**RE: Expedited Settlement Agreement, Number: ES-110524-1  
CDPS Permit No: COR-03F048**

## EXPEDITED SETTLEMENT AGREEMENT

## Stormwater Inspection Report

<b>Permittee:</b> Weaver General Construction Co.	<b>Cert. No.</b> COR03F048	<b>Date(s):</b> September 2, 2010
<b>Facility:</b> Edwards WWTP Solids Processing Facilities Improvements	<b>Industrial Type:</b> Construction	<b>Receiving Water:</b> Eagle River
<b>Facility Address:</b> 3101 Lake Creek Village Drive, Edwards, CO		
<b>Persons present:</b> Joshua Greene (Project Superintendent, Weaver General Construction Co.) and Randy Bruggeman (Assistant Superintendent, Weaver General Construction)		
<b>Legally Responsible Person(s)/Title(s):</b> Tom Baughman (Project Manager, Weaver General Construction)	<b>Inspector(s):</b> Matt Czahor (WQCD) and Nicole Rolfe (WQCD)

Photo 16—Concrete washout area located east of scum room

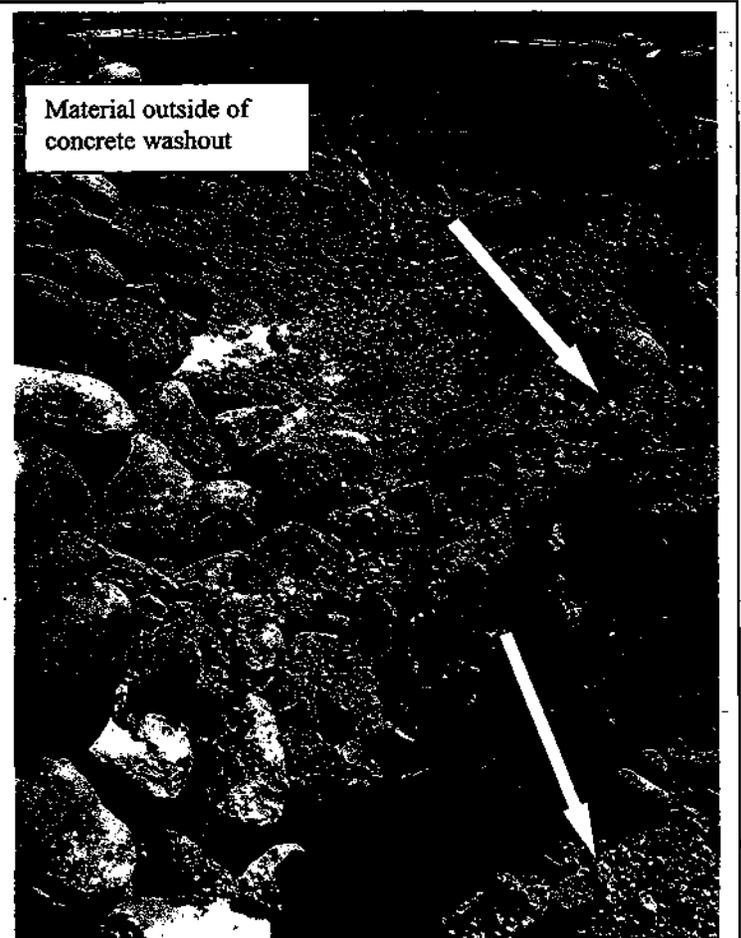
9. It was noted during the inspection that inadequate BMPs were implemented to ensure that concrete washout activities do not result in the contribution of pollutants to stormwater runoff. It was noted during the inspection that concrete washout waste was discharged to the ground east of the scum room. The SWMP did not identify installation and implementation specifications for the concrete washout. The concrete washout was not installed following good engineering, hydrologic and pollution control practices. There was evidence that concrete washout waste as discharged to the ground outside of the concrete washout area (see photo 16). As a result there was potential to contribute pollutants from the concrete washout waste to stormwater runoff that discharges to the south and east and eventually to the Eagle River. All BMPs must be implemented according to installation and implementation specifications outlined in the SWMP. All installation and implementation specifications outlined in the SWMP must follow good engineering, hydrologic and pollution control practices.

Photo 5—Area north of construction trailer

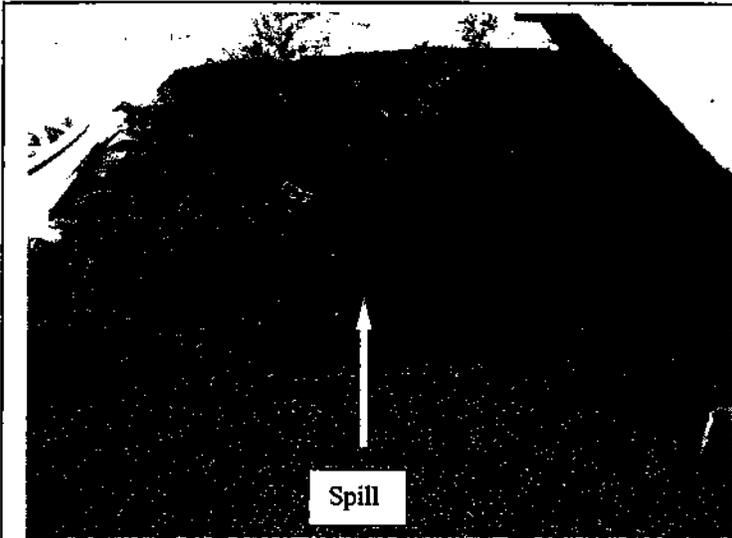
- 5. It was noted during the inspection that a spill occurred in the area north of the job trailer (see photo 5) and in the area north of the bulk storage of fuel area (see photo 6). There was potential for the spill to discharge to the south and southeast and eventually to the Eagle River. The SWMP did not identify spill response procedures. The SWMP must identify spill response procedures for all areas or procedures where potential spills can occur. All spills must be cleaned up in accordance with the spill response procedures identified in the SWMP.

Photo 6—Area north of construction trailer

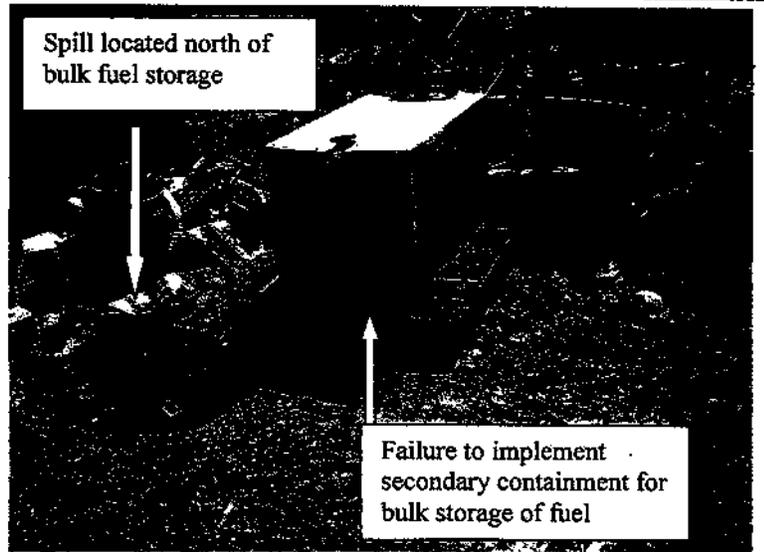
- 6. It was noted during the inspection that the bulk storage of fuel did not have secondary containment (see photo 6) as required by Part I. D.1.c of the permit. The SWMP states the fuel will be stored within a secondary containment vessel of equal and/or greater capacity. A different section of the SWMP states an earthen dike will be constructed around the perimeter of the fuel storage area. However, it was noted during the inspection that the fuel was not stored in secondary containment, nor was an earthen dike was not constructed around the fuel storage area. As a result, there was potential to discharge pollutants to the south and southeast and eventually to the Eagle River. All provisions of the SWMP must be implemented. Bulk storage structures for petroleum products and any other chemicals shall have secondary containment or equivalent adequate protection so as to contain all spills and prevent any spilled material from entering State waters.

Photo --Area east of and adjacent to the head works

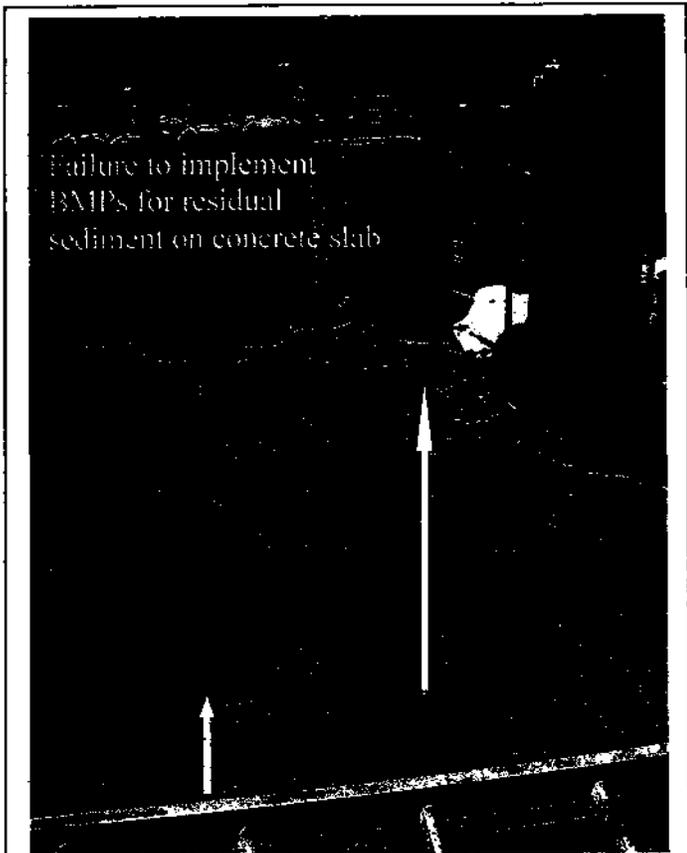
- 2. It was noted during the inspection that BMPs were not implemented to manage stormwater runoff from the area east of and adjacent to the head works (see photo 1). Residual sediment was observed on the concrete slab in this area. Stormwater runoff from this area discharges to the south and eventually to the Eagle River located approximately 250 feet to the south. As a result, there was potential to discharge sediment to the Eagle River. BMPs must be implemented for all potential pollutant sources.

Photo 2—Area east of and adjacent to the head works

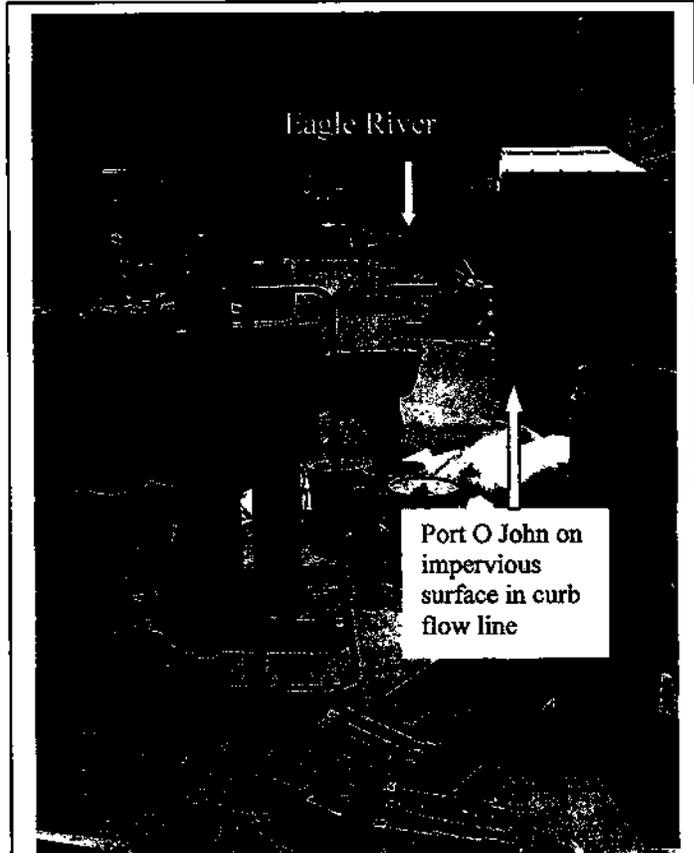
- 3. It was noted during the inspection that BMPs were not implemented to manage the portable toilets located east of and adjacent to the head works (see photo 2). The portable toilets were positioned on an impervious surface and within the flow line. Stormwater runoff from this area discharges to the south and eventually to the Eagle River located approximately 250 feet to the south. If the portable toilets were to spill or leak, there is potential to discharge pollutants to the south and eventually to the Eagle River. BMPs must be implemented for all potential pollutant sources.

Photo 3—Area east of adjacent to the head works and primary clarifier

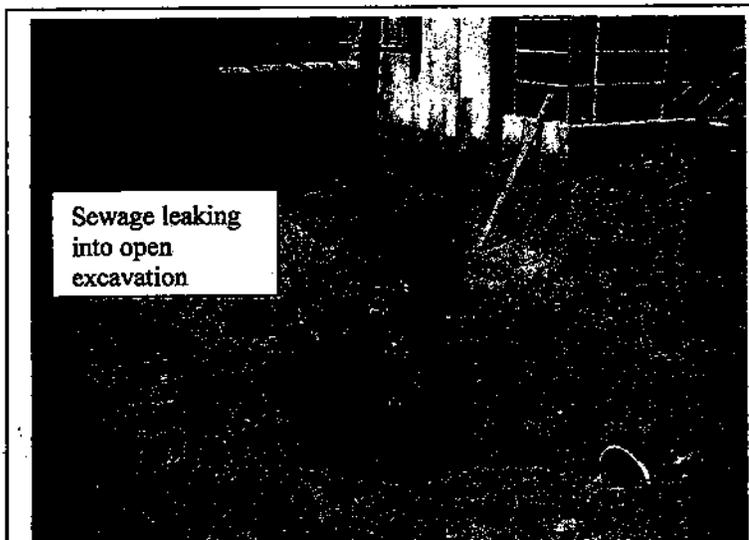
- 4. It was noted during the inspection that there was an ongoing spill of sewage waste from the leaking grit channel into the open excavation located east of and adjacent to the head works and primary clarifier (see photo 3). Sewage waste was observed leaking into the open excavation (see photo 4). As a result, there was an unpermitted discharge of sewage waste to the ground and the potential to discharge pollutants to groundwater.
